Access Compliance Report

Public Rights-of-Way

(Curb Ramps)

Intersection ID: 49399	Main Street: CHILFORD_CT	Cross Street: HEREFORD_ST	Location: SE
ADA ID: 5D98B0EAFC23	Ramp Type: Perp	Initial Pass/Fail: Pass	Overall Compliance: No
Severity Score: 5			
Codes/Mitigation Info/Possible Solution		Field Measurements/Component Compliance

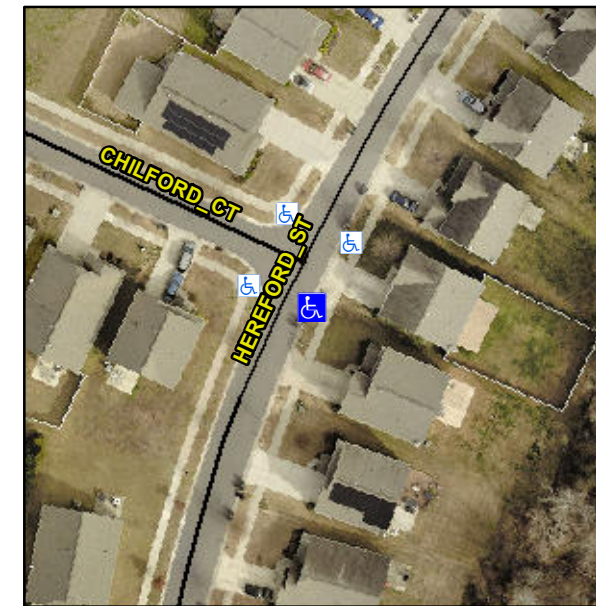
Not Found, R304.5.4

Compliance	Description	Data	Compliance	Description	Data
N/A	Ramp Length (in)	71.5	Yes	Ramp Slope (%)	7.1
Yes	Ramp Width (in)	48.0	Yes	Ramp XSlope (%)	0.7
N/A	Flare Type LT	Sloped	N/A	Flare Type RT	N/A
N/A	Flare Slope LT (%)	1.8	N/A	Flare Slope RT (%)	5.6
N/A	Flare Traversable LT?	Yes	N/A	Flare Traversable RT?	No
Yes	Landing Length (in)	59.0	Yes	DWS Provided?	Yes
Yes	Landing Width (in)	48.0	Yes	DWS Contrast?	Yes
Yes	Landing Slope (%)	1.6	Yes	DWS Length (in)	24.0
Yes	Landing X Slope (%)	1.9	Yes	DWS Full Width?	Yes
N/A	Landing Curb? (Y/N)	No	Yes	DWS Offset (in)	2.0
N/A	Shared Landing?	No			
Yes	Gutter Ponding?	No	No	Gutter Slope (%)	6.8
Yes	Gutter Lip Ht (in)	0.0	Yes	Gutter X Slope (%)	0.9
N/A	Painted X Walk1?	No	N/A	Painted X Walk2?	N/A
	X Walk 1 Direction	To NW		X Walk 2 Direction	N/A
N/A	X Walk 1 Width (in)	N/A	N/A	X Walk 2 Width (in)	N/A
	X Walk 1 Slope (%)	3.8		X Walk 2 Slope (%)	N/A
	X Walk 1 X Slope (%)	1.7		X Walk 2 X Slope (%)	N/A

N/A	Ramp inside XWalk1?	N/A	N/A	Ramp inside XWalk2?	N/A
	Road Slope (%)	N/A	N/A	Clear Space?	Yes
	Road X Slope (%)	N/A	N/A	Clear Space to XWalk (in)	N/A
Yes	Any Obstructions?	No	Yes	Storm Grate/Utility Hazard?	No
	Obstruction Type			Storm Grate/Utility Type	
		N/A			N/A
			Yes	Surface Condition? (G/P)	Good

**Remove & Replace Entire Ramp.
Remove & Replace Gutter.**
